# **FINDING OF EFFECT MEMORANDUM**

**March 27, 2020**

**Historic Property:** Golden Gate Village  
**Project Name:** Temporary Onsite Modular Office  
**Street Address:** 101–429 Drake Avenue and 1–99 Cole Drive, Marin City  
**Project Applicant:** Marin Housing Authority, County of Marin  
**Lead Agency:** County of Marin  
**Contact:** Evan Smith, esmith@marinhousing.org

**Figure 2: A site plan illustration of the proposed location and orientation of the 64' x 12' modular unit, shown in red. North is up, Highway 101 is to the east; not to scale. Courtesy: Google Earth, 2019**

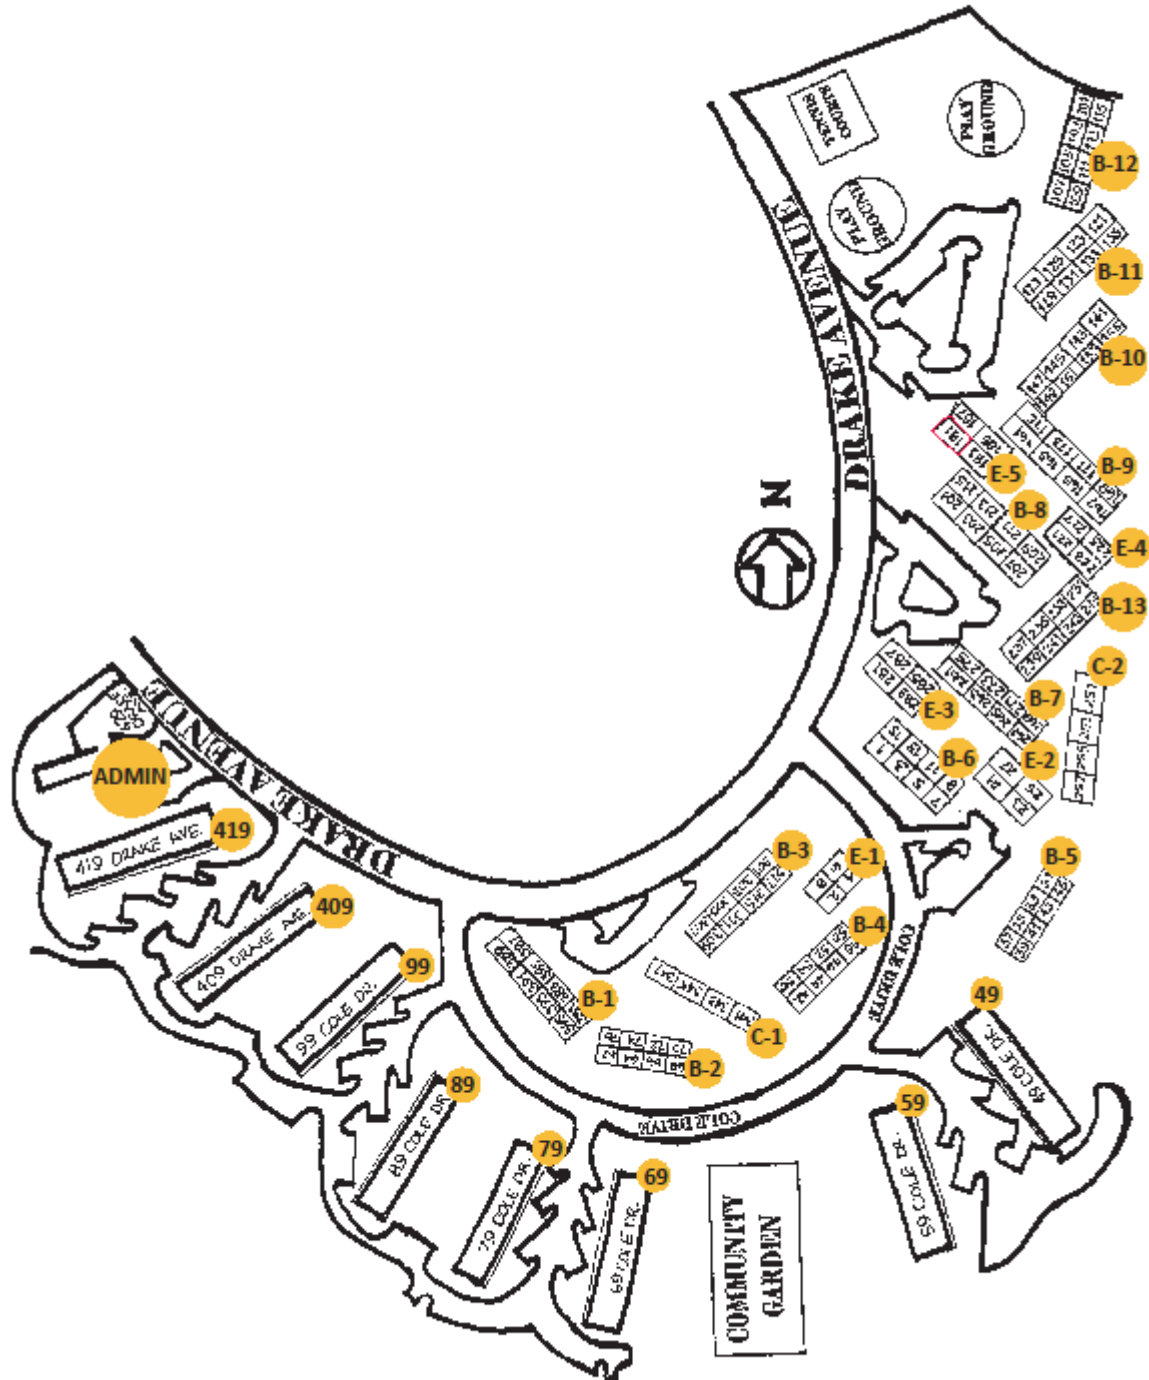
**Comment:** The proposed undertaking would introduce a new temporary building (one modular unit) within the boundaries of the NRHP-listed historic district between Building E5 and the residential subdivision to the west. The unit would be sited on the lawn between Drake Avenue to the west, between the site's two northern parking lots to its north and south, and Building E5 to the east. The new modular unit would not diminish the existing buildings' historical relationship to each other because the unit would not be located between any of the existing buildings, but rather it would be located on the edge of the property.

Additionally, the new modular unit would not diminish any character-defining views or vistas. Nearby contributing buildings include E5 and several examples of the two-story B low-rise type (Buildings B8, B9, B10, B11). The B type buildings are approximately 23.5-foot tall, and the E type building is approximately 12.5-foot tall. The modular unit would be approximately 10.5-foot to 11-foot tall, which is lower in height than the contributing low-rise buildings. Therefore, the modular unit would not block significant views.

The modular unit would introduce a new visual element into the historic property but would be clearly differentiated from the character-defining buildings and compatible in proportion and spatial relationship to the cultural landscape.

The parking lots on the north and south sides of the lawn where the modular unit would be placed, and the concrete sidewalks surrounding the lawn are character-defining features of the cultural landscape. The proposed undertaking would not alter these features. Furthermore, no character-defining vegetation would be removed for the installation of the modular unit. Where and if the lawn ground-cover is damaged during the project, it will be repaired to pre-project conditions after the undertaking is complete.

The materiality and appearance of the façade of the modular unit should be compatible with the neighboring contributing buildings. The modular unit manufacturer's website notes the unit can have either wood or aluminum siding. Wood siding painted a neutral color would be compatible with the neighboring contributing buildings.

While no vegetation is anticipated to be removed while the modular unit is onsite, to ensure compatibility with the manicured lawn of the low-rise cluster, the lawn around the unit and underneath the steps and ramp should be properly maintained. This may include weed whacking to maintain a low groundcover.
